ADDENDUM NO. 1 DATED 3/16/2009 ADDENDUM NO. DATED
 ADDENDUM NO. DATED ADDENDUM NO. DATED

Number	Description
1	Revised Table of Contents; Added Notice to Bidders #2438; Added Special Provision #907-413-2; Revised Bid Sheets; Amendment EBS Download Required.

PROJECT: NH-0009-01(123) / 105437301 -- Adams County

SECTION 904 - NOTICE TO BIDDERS NO. 2438

**PROJECT FUNDING SOURCE SIGN ASSEMBLY
AMERICAN RECOVERY AND REINVESTMENT ACT
SIGN LAYOUT DETAILS**

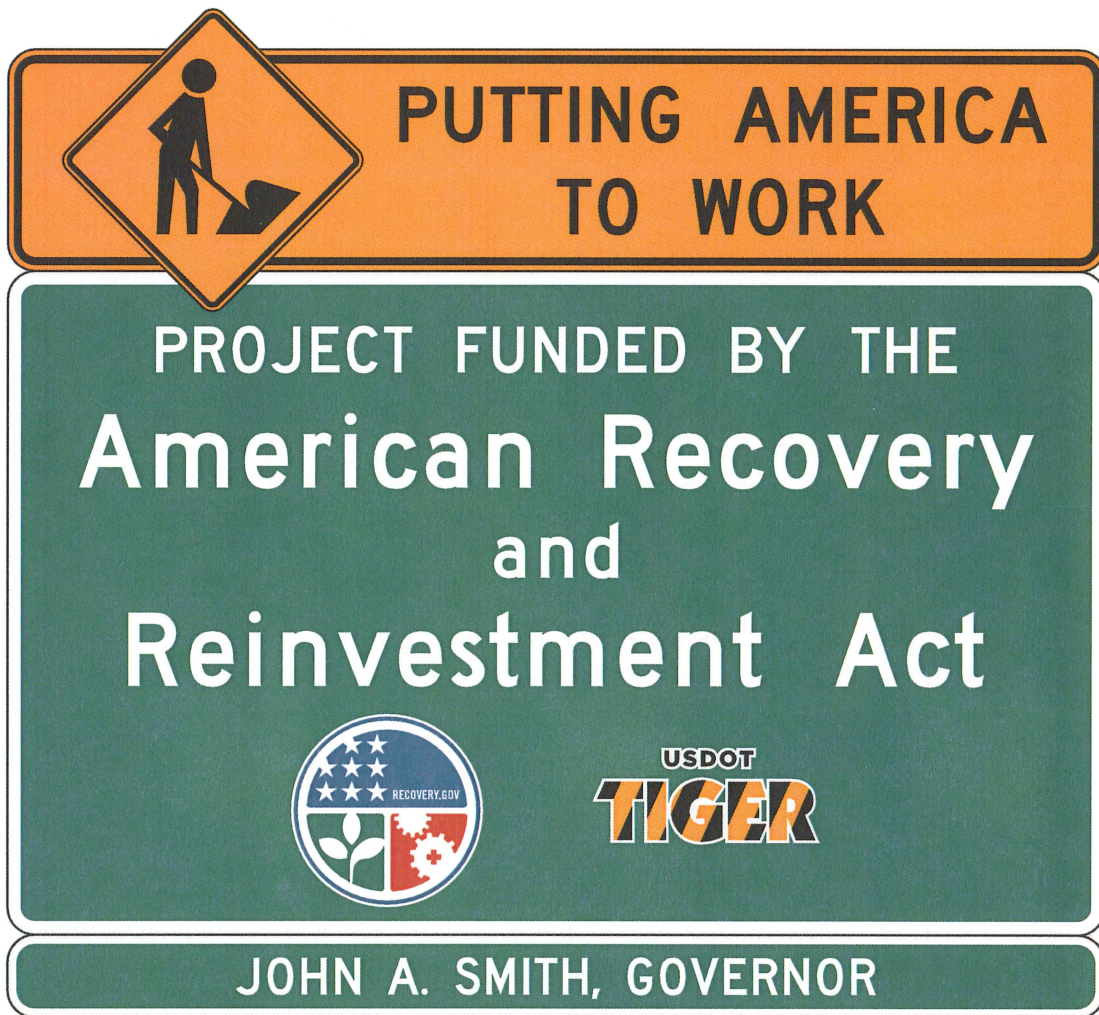
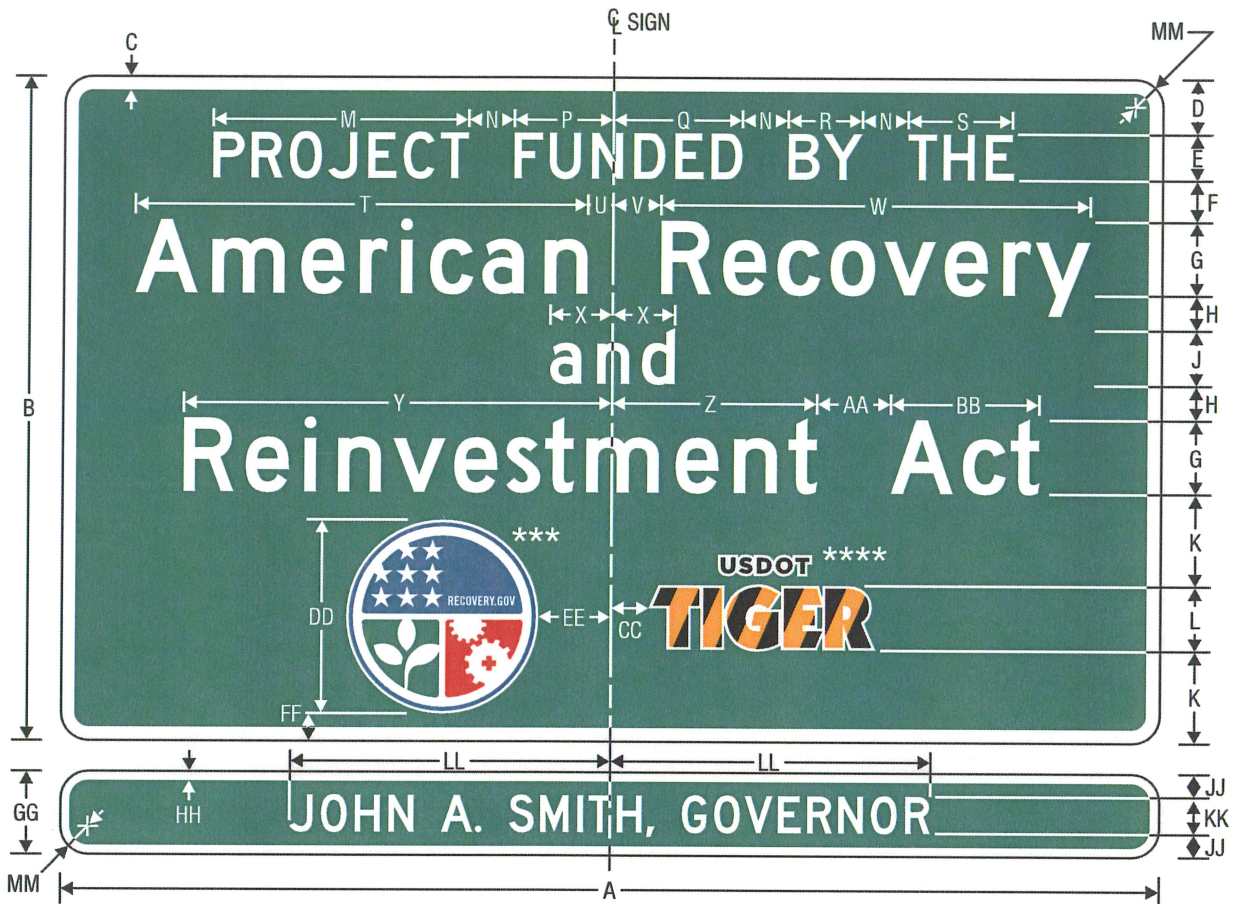
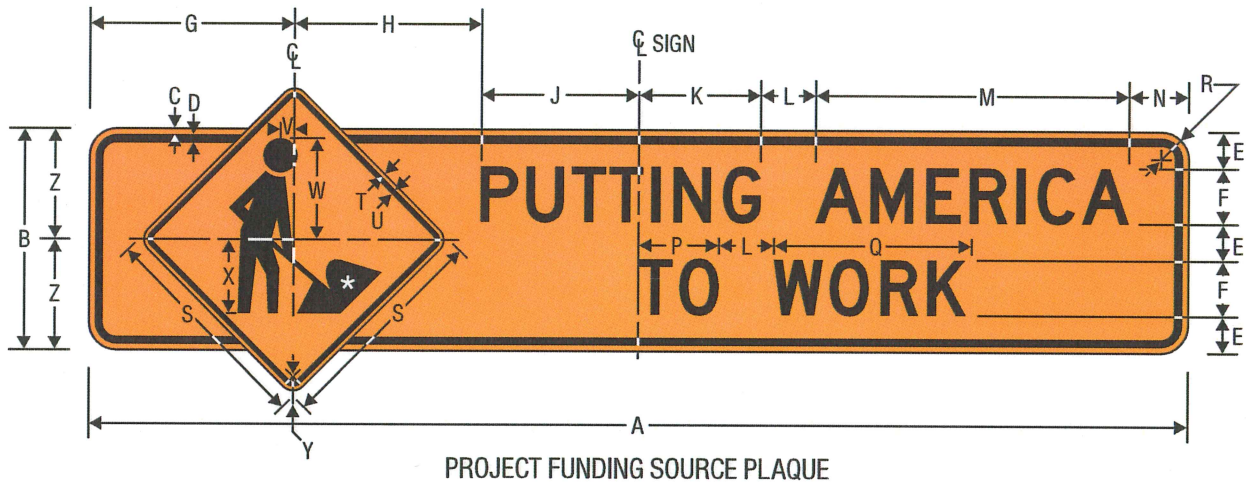
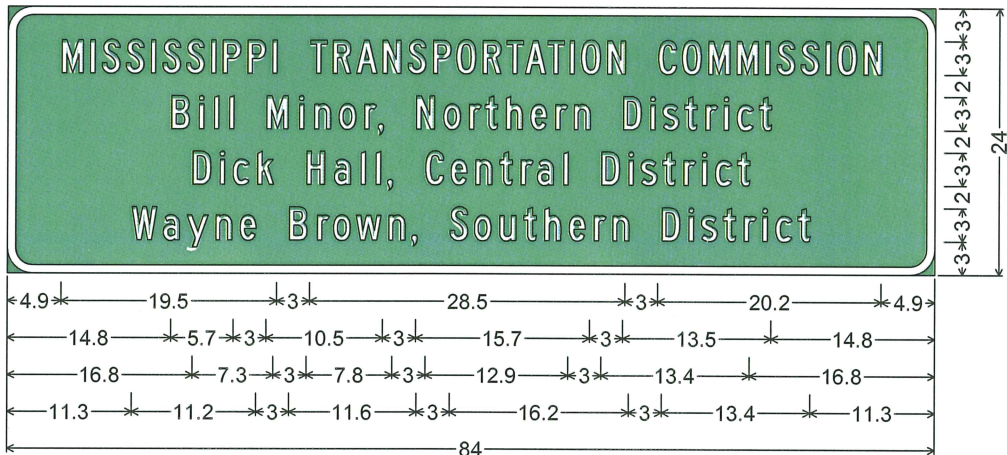
Bidders are hereby advised that the Contractor shall install, maintain, and remove two (2) economic recovery signs at the beginning (BOP) and end (EOP) of this project, unless otherwise directed by the Engineer. A picture of the signs and the dimensions of the signs are shown on the attached sheets. The signs shall be constructed, installed and maintained in accordance with the MUTCD, and Sections 618 & 619 of the Standard Specifications. These signs shall be fabricated from 0.125" sheet aluminum. Signs shall be mounted on three (3) - three pounds per linear foot (3 lbs. / ft.) U-Section posts. Each post shall be 14 feet long mounted onto another 14-foot U-Section post driven halfway into the ground. All cost of installing and maintaining the signs, including material, labor, posts, hardware, etc., will be measured and paid for under the pay item no. 619-D4.
